The Albion-Sheridan Landfill PRP Group

Subject: Response to April 21, 1997 MDEQ Letter And April 7, 1997 EPA E-mail
Albion-Sheridan Township Landfill, Albion, Michigan
Project No. 6E13045

DRN BY: KAH	DATE: APR. 1997	PROJECT NO. 6E13045	FIG. NO. 1
CHK'D BY: DS	DATE: APR. 1997

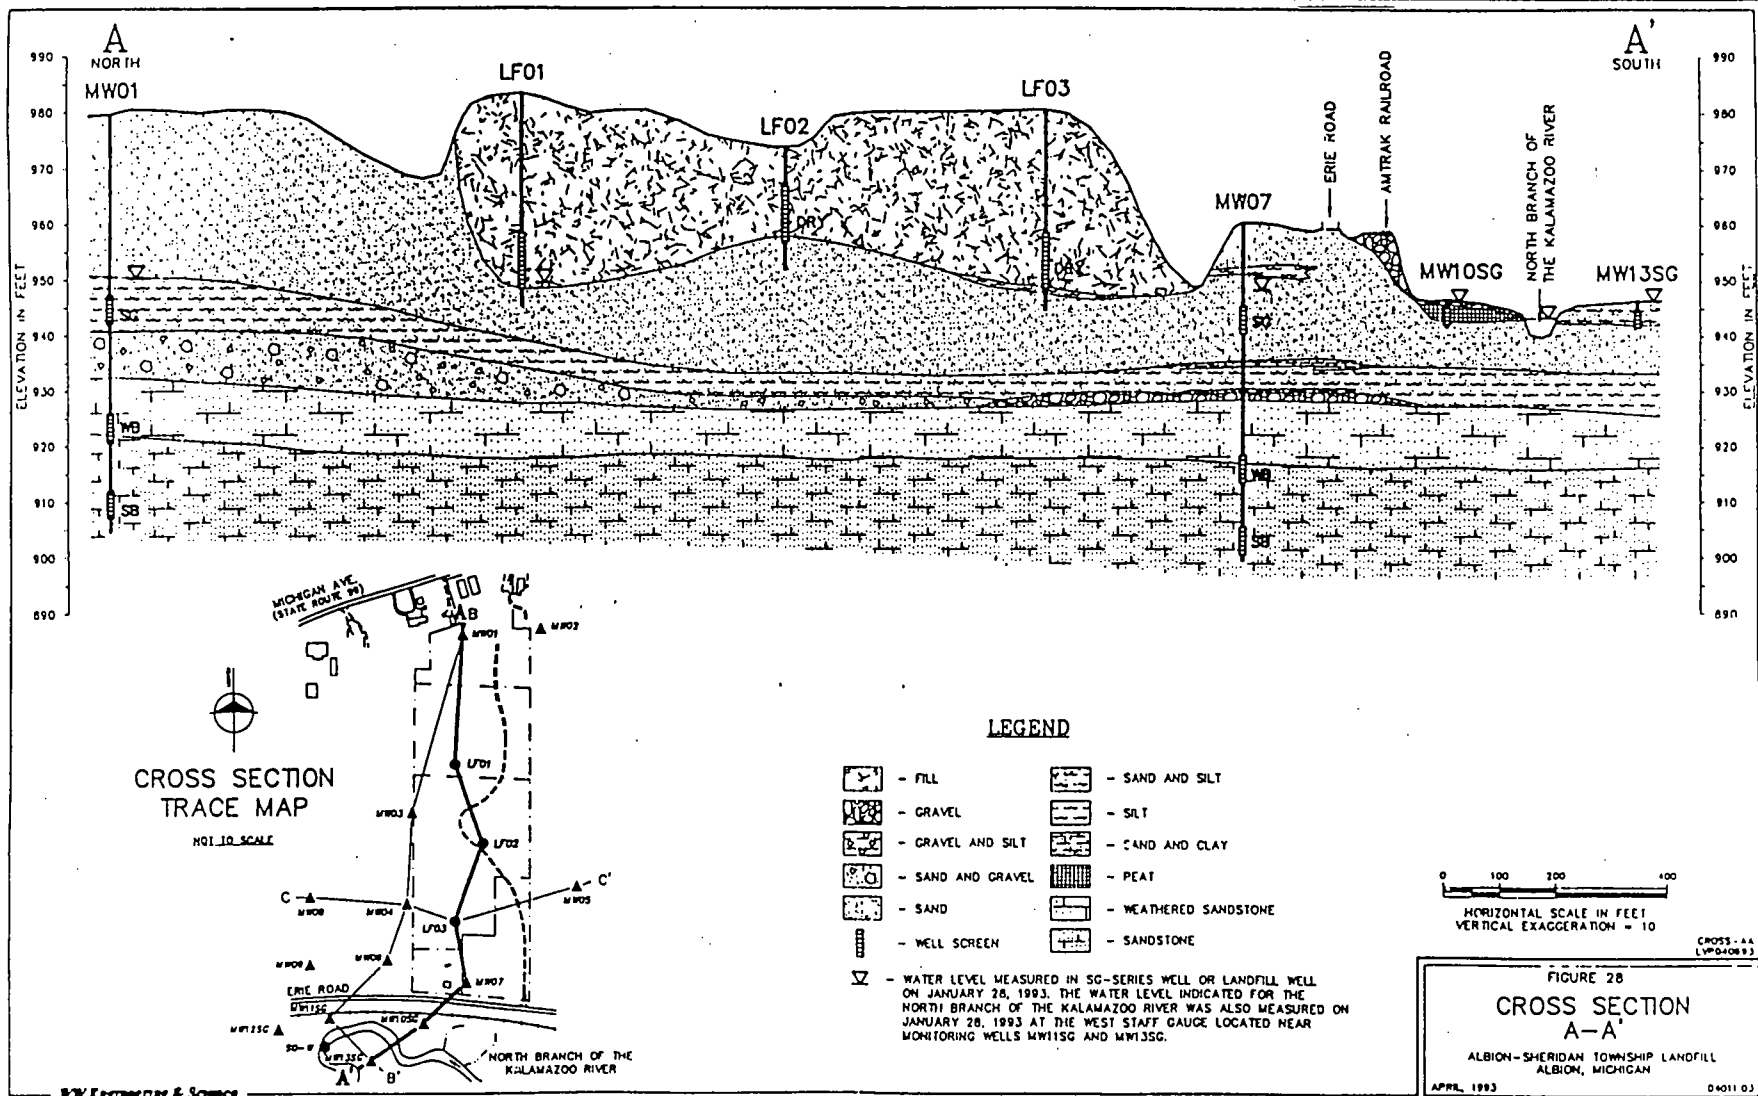
The Group disagrees with the recommended location of the remaining well, which is to be placed in the shallow or weathered bedrock on the south side of the river. The hydrogeologic and analytical information that would be gathered at this location would not detect site constituents because the groundwater migration direction in the recommended location is from south to north, toward the river, and toward the site, and not from the site toward the

well. Figure 1 (attached) presents a hydrogeologic cross-section that shows there is no possibility for dissolved constituents to cross under the river because it is a hydraulic divide for the unconfined aquifer at the site and extending to the river.

The vertical groundwater gradient in clustered wells confirm an upward gradient from the shallow bedrock to the overlying weathered bedrock in the monitoring locations between the landfill and the river. Further, there is an upward gradient from the deep bedrock to the shallow bedrock in the MW16 cluster adjacent to the river. These data further support our conclusion that the groundwater would not flow under the river.

The Group suggests that if MDEQ believes an additional well is necessary, that it be located north of the railroad tracks to detect potential landfill constituents.
